Circular No : URA/PB/2019/09-DCG  
Our Ref : DC/ADMIN/CIRCULAR/PB\_19  
Date : 5 July 2019

## **CIRCULAR TO PROFESSIONAL INSTITUTES**

## **REVISION TO THE LANDSCAPE DECK GUIDELINES – REMOVAL OF EARTH BERMING REQUIREMENT**

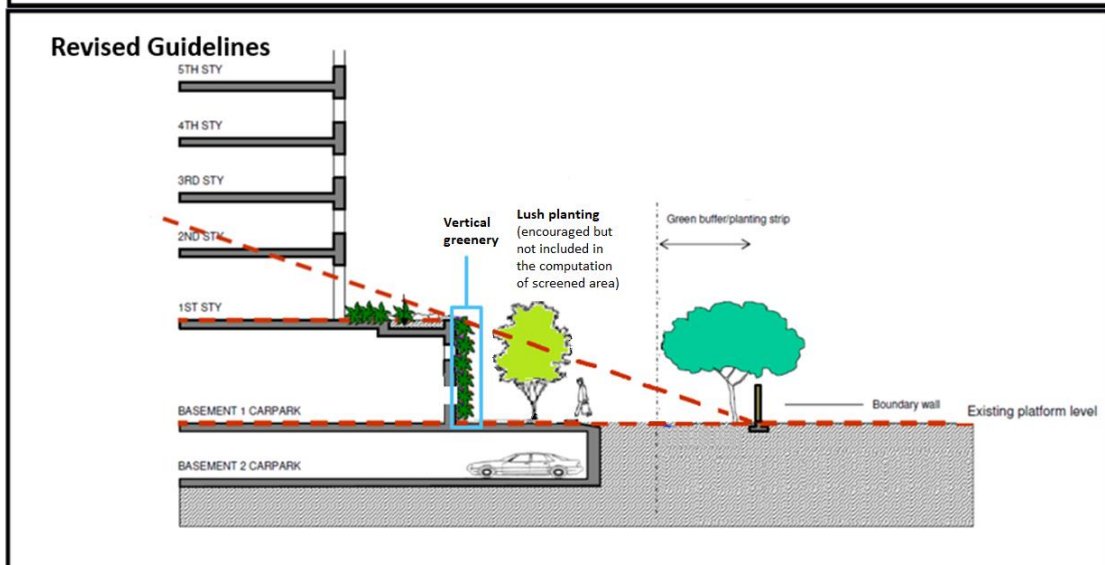
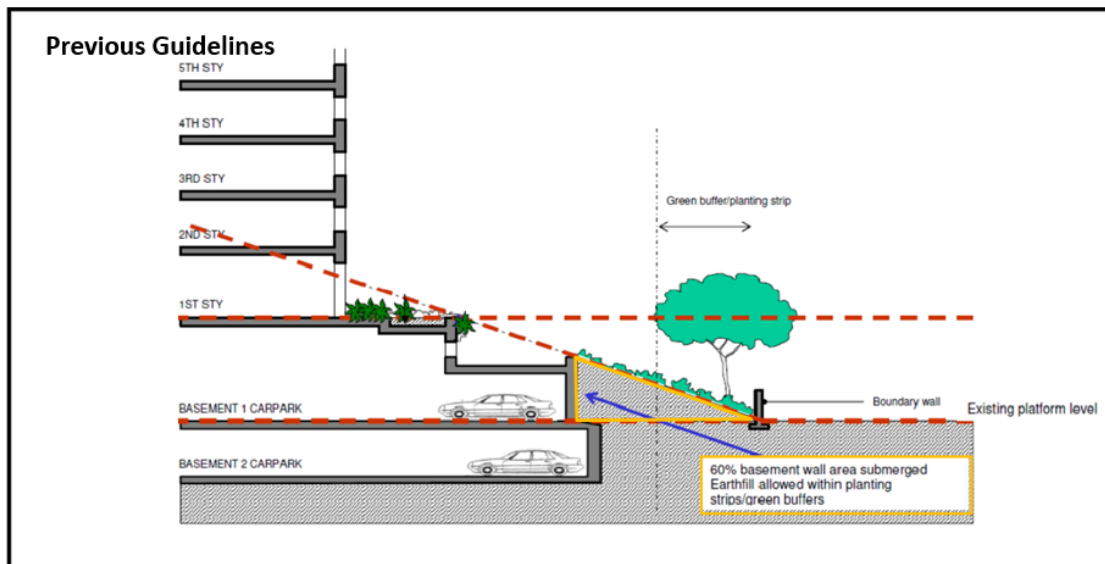
1. Landscape decks are raised carpark decks that are partially concealed with greenery and earth berm to mitigate its visual impact on the streetscape. The landscape deck guidelines were introduced in 2004 for residential non-landed developments to provide an alternative to basement carparks or multi-storey carparks. The guidelines have now been revised to allow the removal of the earth berm if vertical greenery are provided along the edge of the landscape deck to minimise its visual impact.
2. The revision is in response to industry feedback that the earth berm requirement adds substantial construction cost and limits design options for the landscape deck. Under the revised guidelines, the space previously used for the earth berm can be freed up for other uses such as communal facilities, landscaping or circulation spaces ([Appendix 1](#)).

3. To sufficiently screen and to mitigate the visual impact of the landscape deck, at least 50% of the exposed wall of the deck at each facade must be screened with vertical greening<sup>1</sup>. Elevation plans showing the screened wall with respective coverage area in square metres should be provided<sup>2</sup> ([Appendix 2](#)).
